Store #12418
Approved with Changes
8-19-08

QUINZOS 12418
1114 TOTAL S.F.
9'-6" CEILING

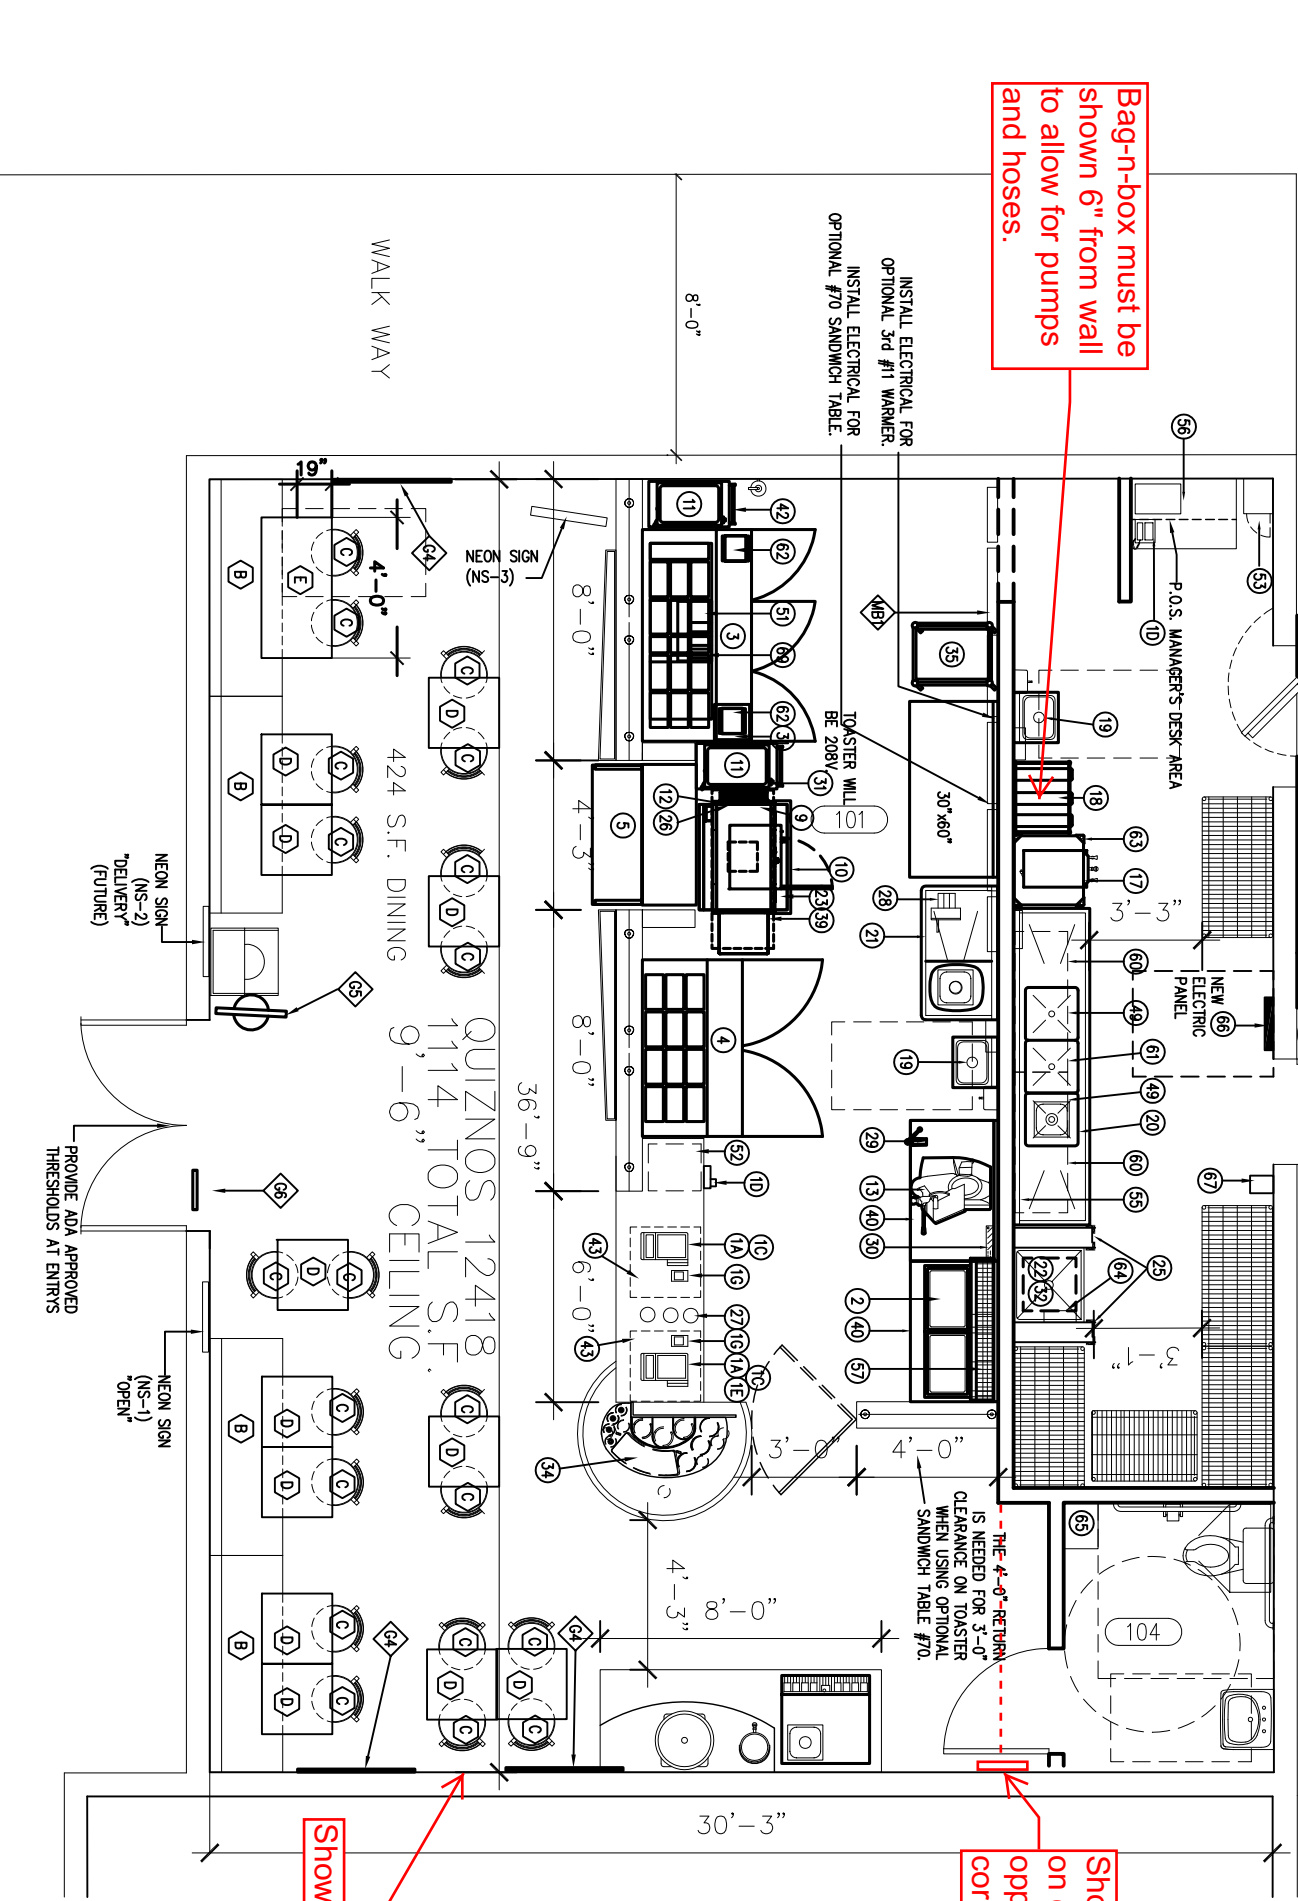
Bag-n-box must be shown 6" from wall to allow for pumps and hoses.

Show sconce

Show plaster on center with opposite corner.
